Product Change Notification

PCN20-23-JS Series Slide Switch Base Material Improvement

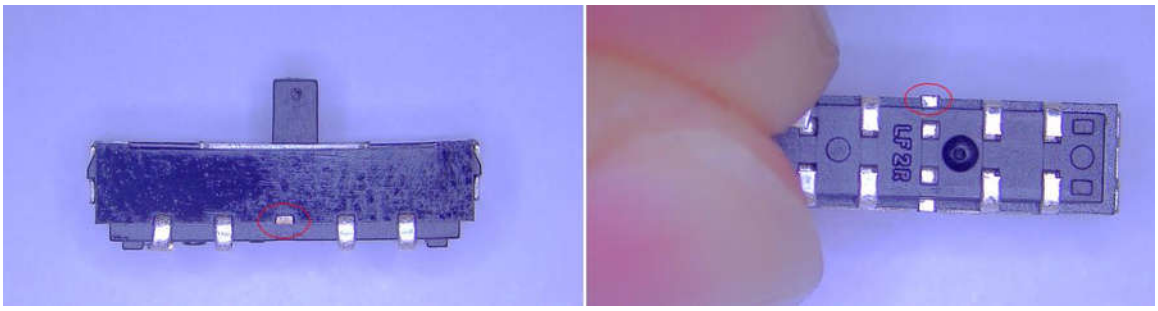
3.1 The base material plastic is changing from PA46 to PPA in order to leverage the lower water absorption of PPA as compared with PA46.

3.2 There is an associated cosmetic change in switch appearance as seen in the pictures below showing a trimmed off additional terminal in the middle of the switch base. This terminal is trimmed off such that it extends no more than 0.3mm outward from the switch base after trimming.
